Addendum #1

Bid Opportunity: 22-7352-RFT - Central Public School - Accessibility, HVAC & Window Upgrades

FLOOR PATTERN PLANS

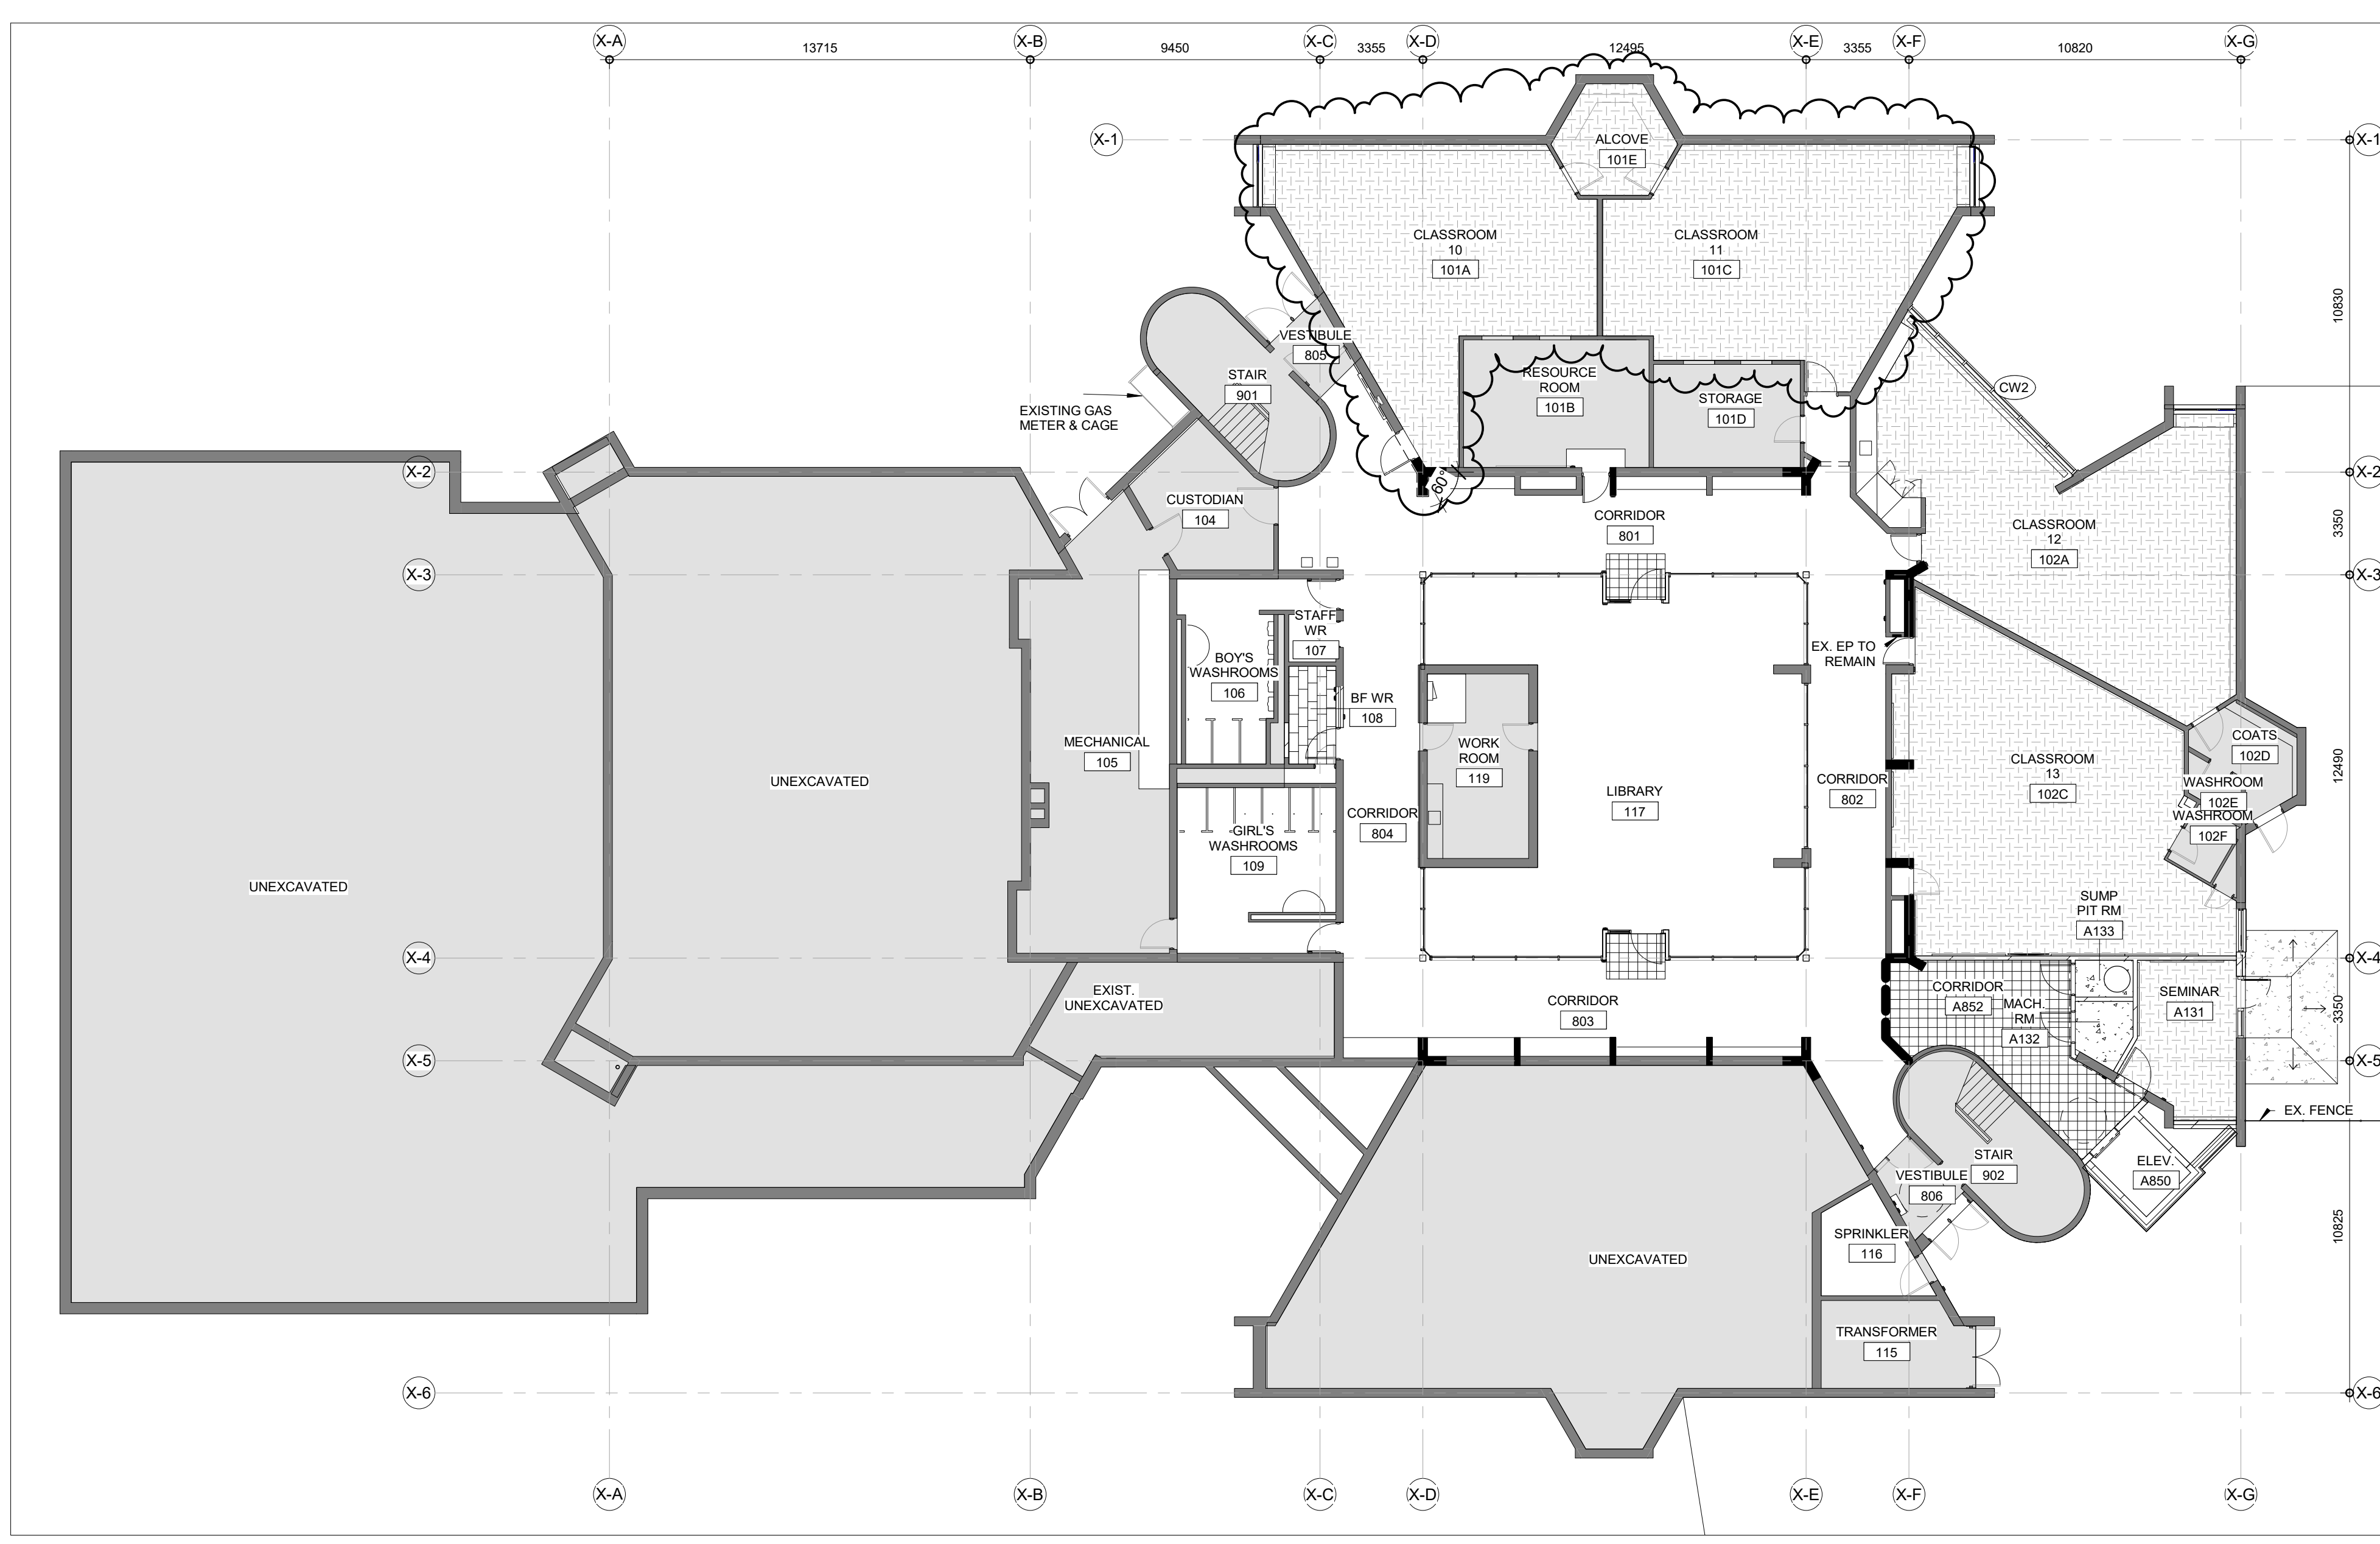
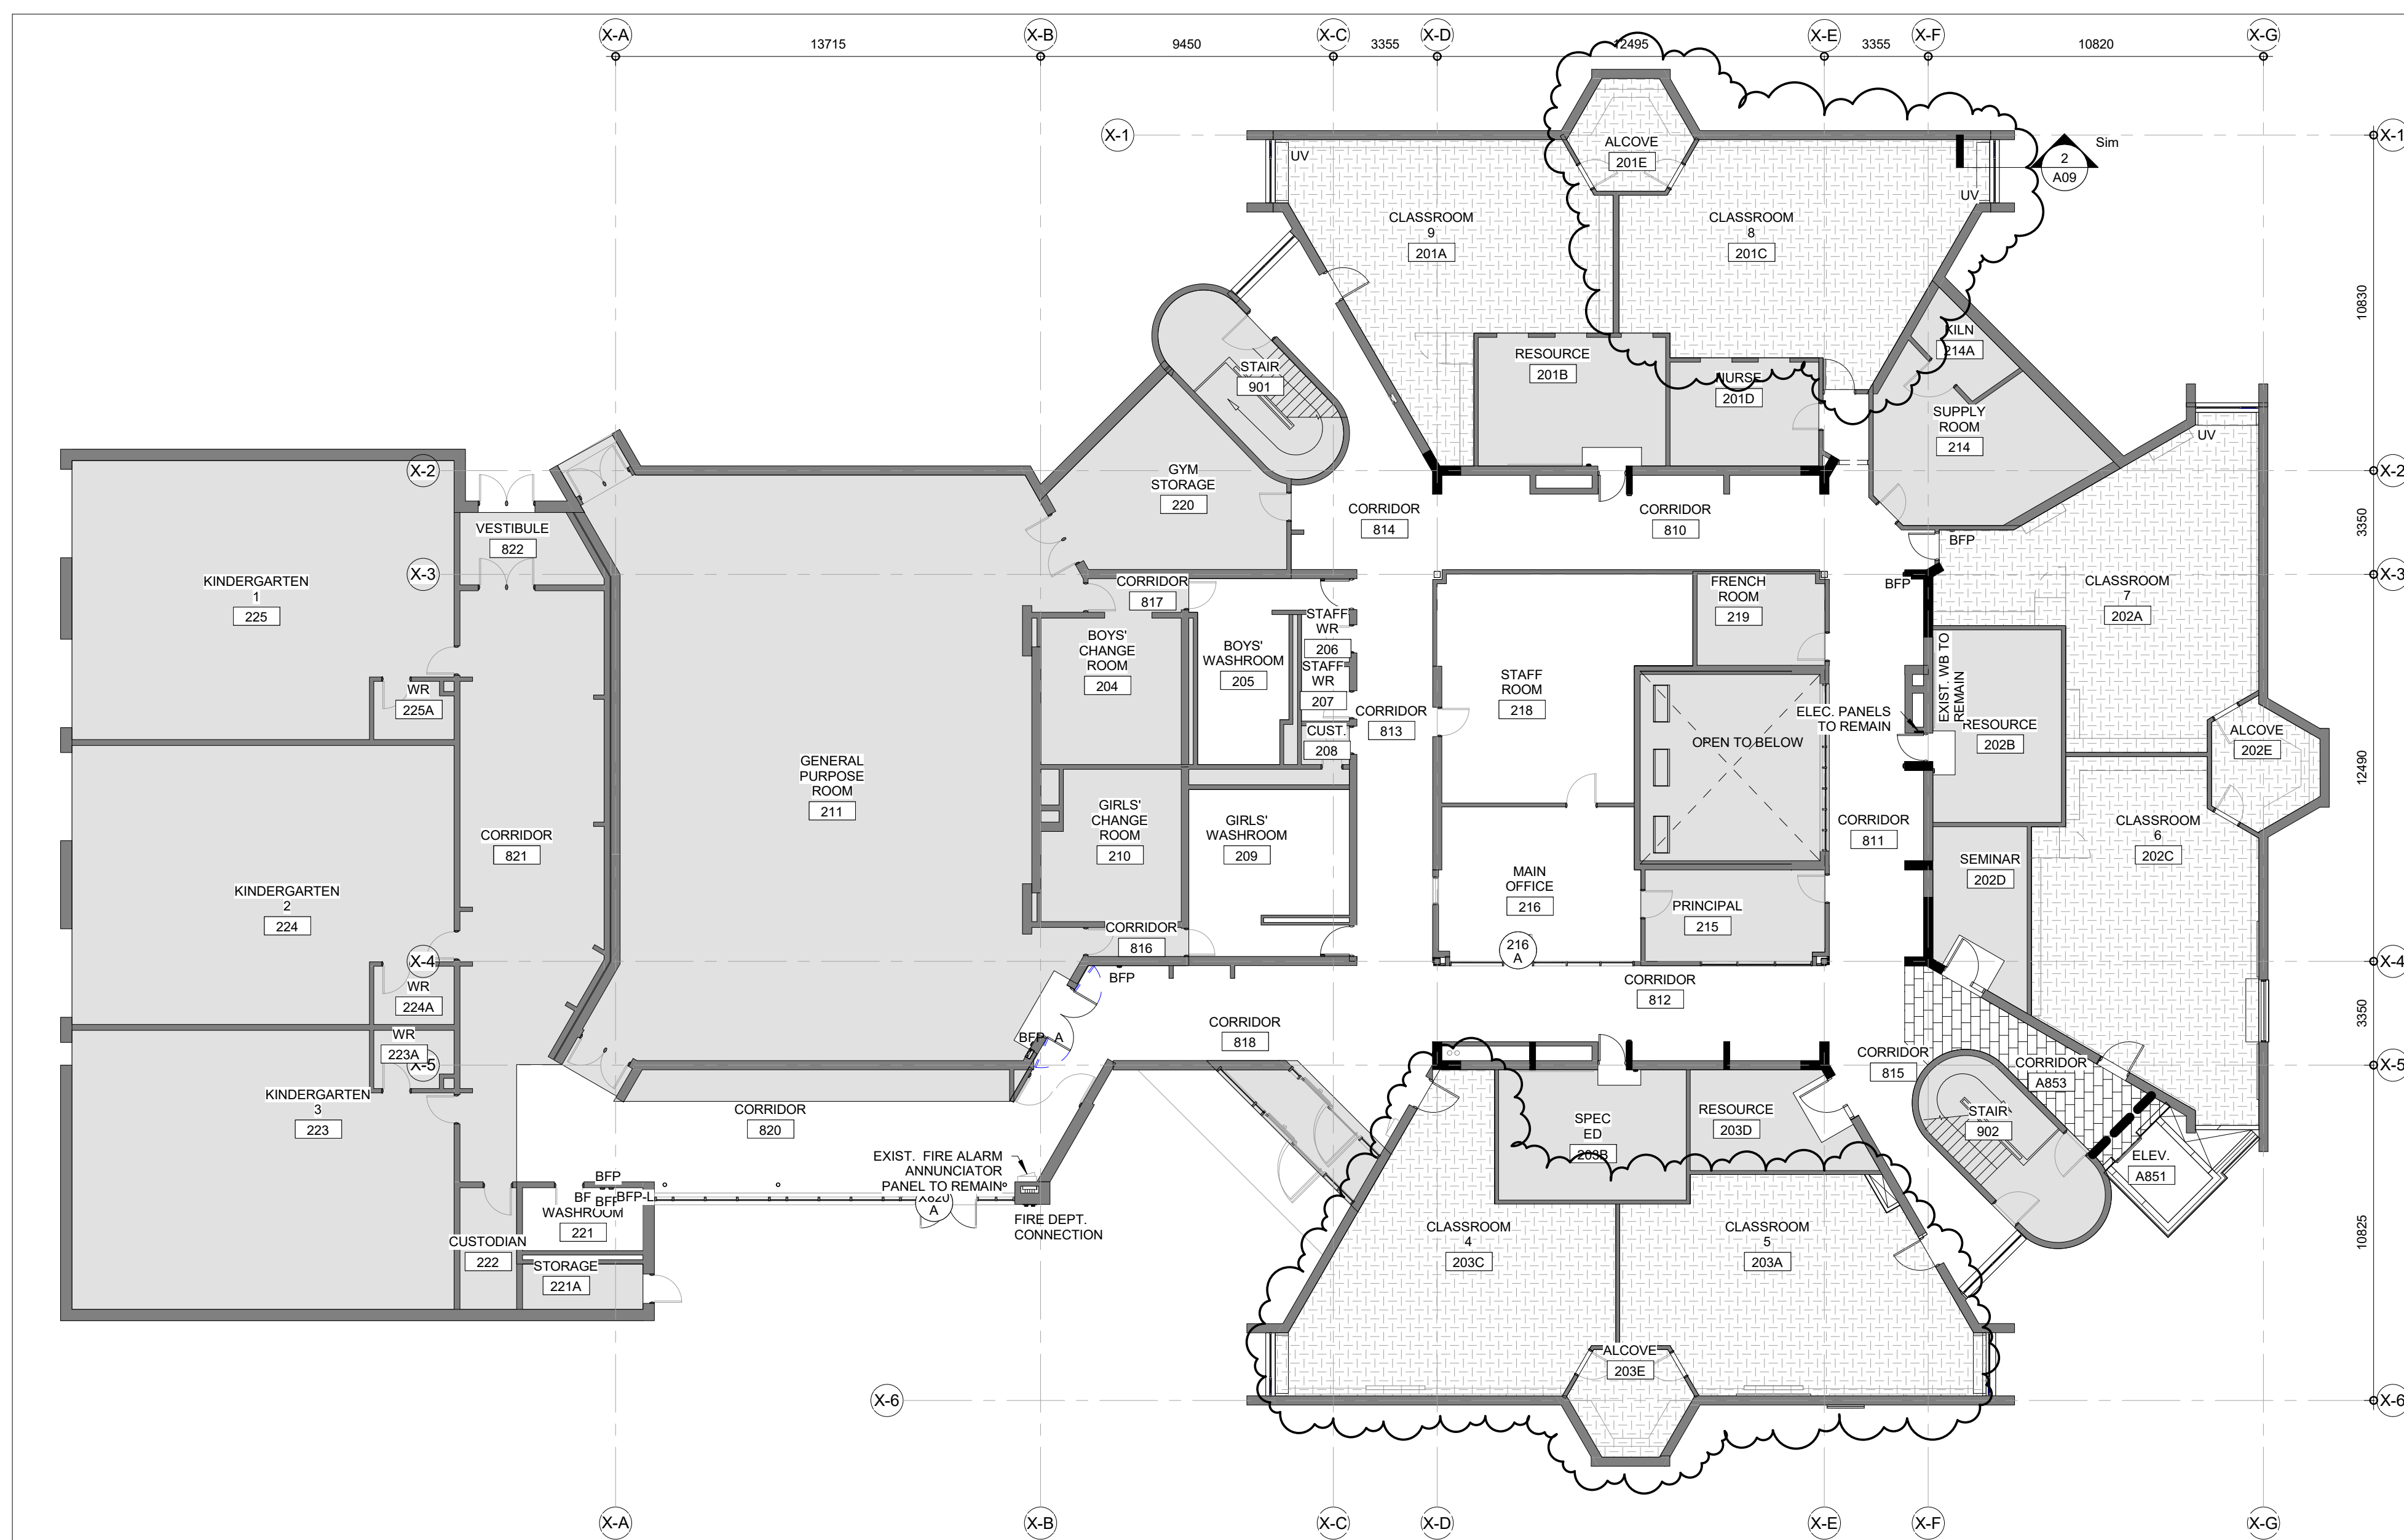
Item 8 – A11 – Floor Pattern Plans

- .1 REPLACE drawing A11 with attached.
